**GM 1.7D (ISUZU) / Synchronous Drive / Tensioner Info.**

<b>GATES REFERENCE:</b>	<b>5563XS &amp; related kits.</b>	
<b>MAKE:</b>	CHEVROLET / OPEL / VAUXHALL.	
<b>MODEL:</b>	Astra, Combo, Corsa, Cruze, Meriva, Mokka, Trax, Vita, Zafira.	
<b>MOTOR:</b>	1.7CDTI, 1.7D, 1.7DI, 1.7DTI.	
<b>MOTOR CODE:</b>	A17DT, A17DTC, A17DTE, A17DTF, A17DTJ, A17DTL, A17DTR, A17DTS, Y17DT, Y17DTL, Z17DT, Z17DTH, Z17DTJ, Z17DTR.

This Technical Bulletin replaces Technical Bulletin N° 009.

Fig. 3

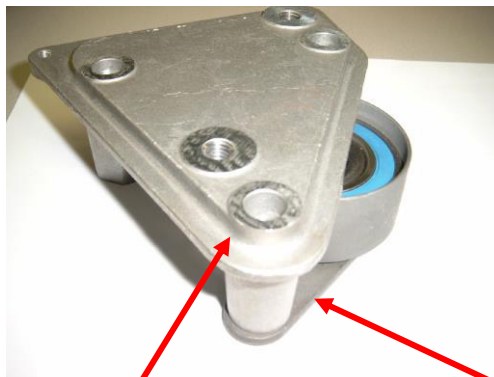
As the initial tensioner base plate was fitted under a leg of the engine support bracket (Fig. 3), K015563XS can only be used from engine nr 328704 on.

Fig. 4

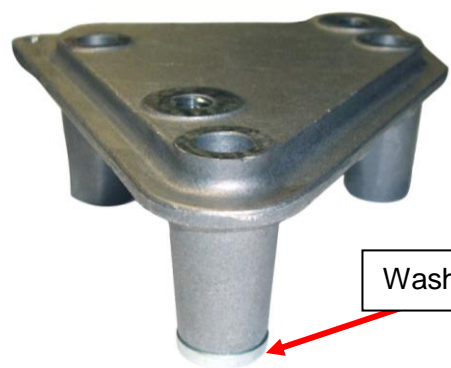
K025563XS is supplied with a washer to compensate the lost thickness of the base plate under the shorter leg of the early engine support bracket as in Fig. 4, and contains a stud which is needed to hook the new tensioner spring on (Fig. 5). This K02 can always be used: up to engine nr 328703, using the washer and the stud; and from engine nr 328704 without the washer and the stud.

Fig. 5

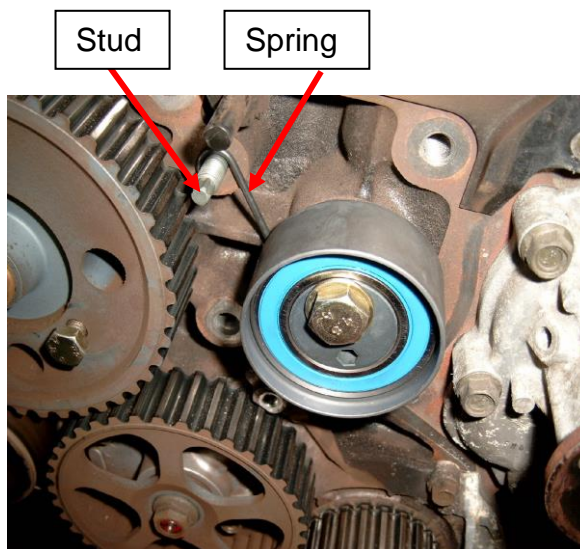
- 1) Remove the used tensioner, spring, idler and belt.
- 2) Install the new idler and bolt.
- 3) Insert and torque (18.6 Nm) the stud at the right hand side of the injection pump pulley (Fig. 5).

Fig. 6

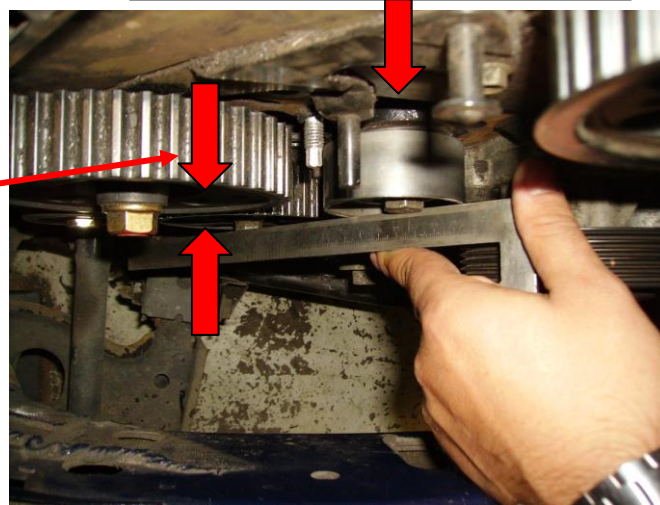
- 4) Install the new coil spring tensioner (spring over stud, bolt hand tight); make sure tensioner is sitting perfectly against engine block. If not, the spring could end up between the tensioner and the engine block, creating a serious tensioner misalignment (see Fig. 6).
- 5) Rotate the tensioner anticlockwise (Allen key) till the Allen key hole is in +/- 5 o'clock position.
- 6) Tighten the bolt.

Spring trapped behind tensioner

Serious misalignment

Fig. 7

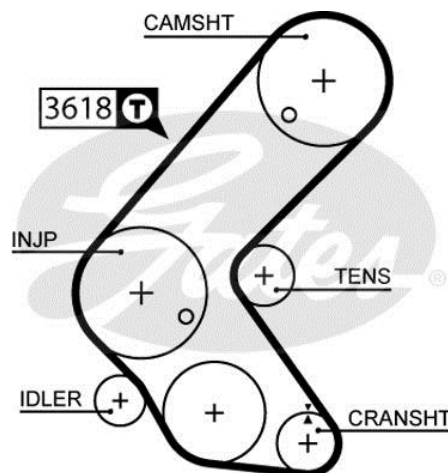
\*\* After completing step 10 of the installation in procedure A), or step 9 in procedure B), it is highly recommended to check the tension in span **T**, (see drive system layout below - Fig. 7) using Gates Sonic Tension Tester STT-1.

Enter code 3618 in the STT-1 (ensure chip version 006 is installed) then measure in the normal way. If the tension is too high then the tensioner should be completely released and tensioning procedure repeated until the green light is obtained.

If the tension is too low then it will be necessary to assist the tensioner spring with the Allen key; until the green light is obtained.
